## City of Sedona Wastewater Department

The City of Sedona, Arizona is issuing **Addendum # 1** to the plans and specifications as originally issued at the time of solicitation for bids for the **Remodeling for Wastewater Reclamation Plant Administration Building**. For any bid to be considered responsible and responsive, receipt of this addendum must be acknowledged.

- Supplemental Mechanical

EXHIBIT 1

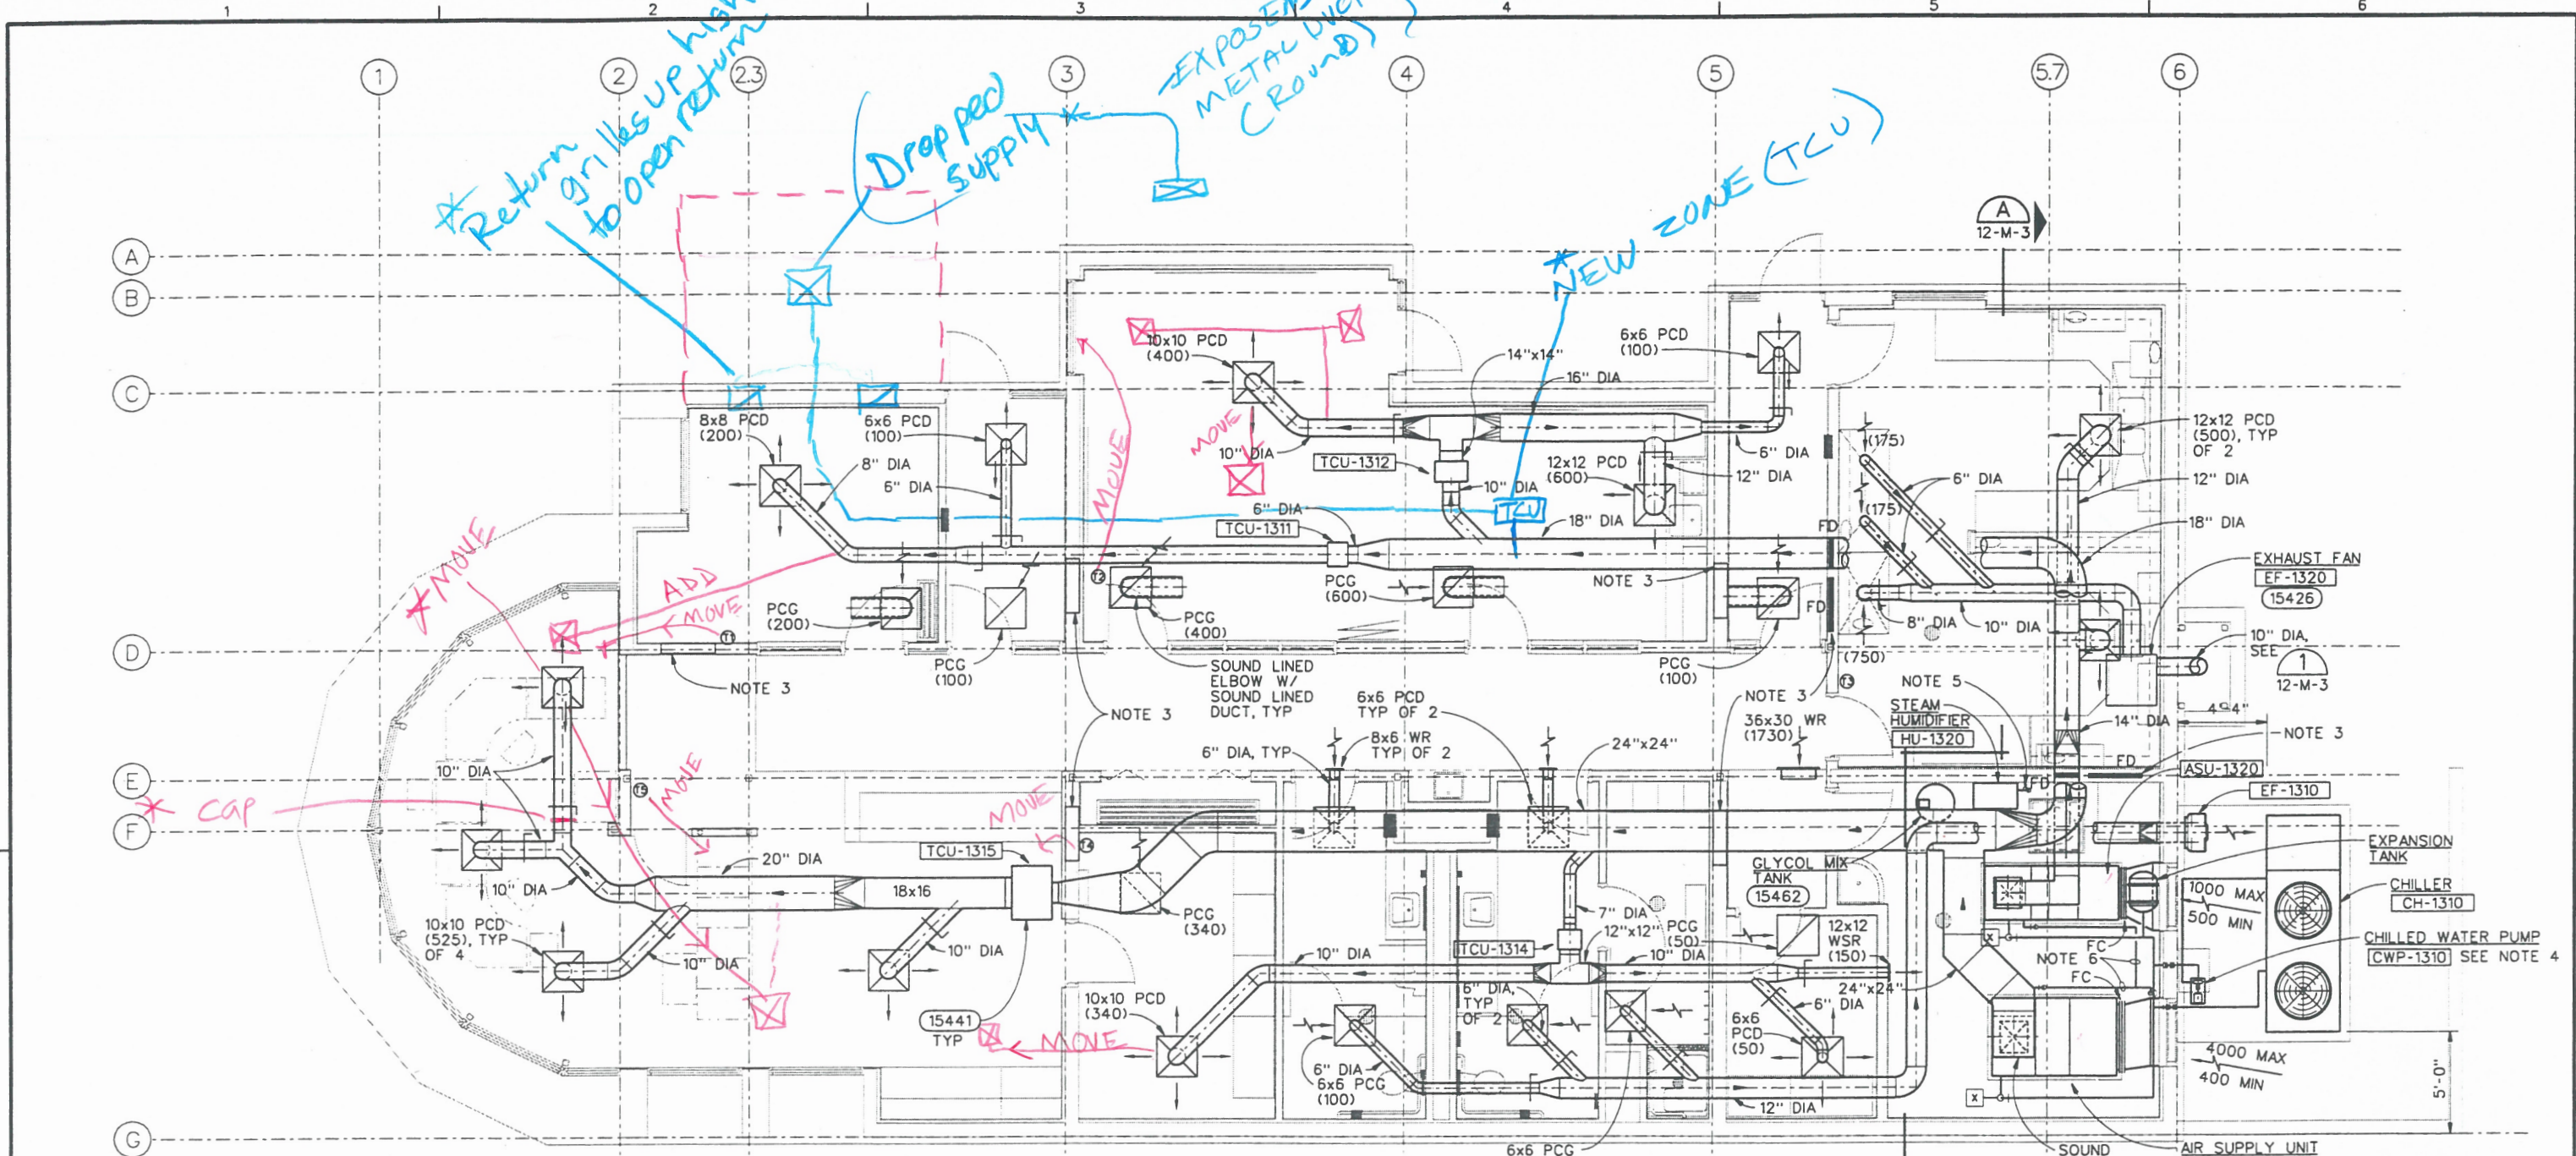
\* HVAC control system (complete) including valves, actuators, controllers, zone sensors, TCU controls, start/stop, etc.  
 \* EXISTING TCU'S will remain, But they will be retrofitted with new controls

ADD OR MOVE OR RELOCATE EXISTING LOCATIONS  
 \* NEW ZONE
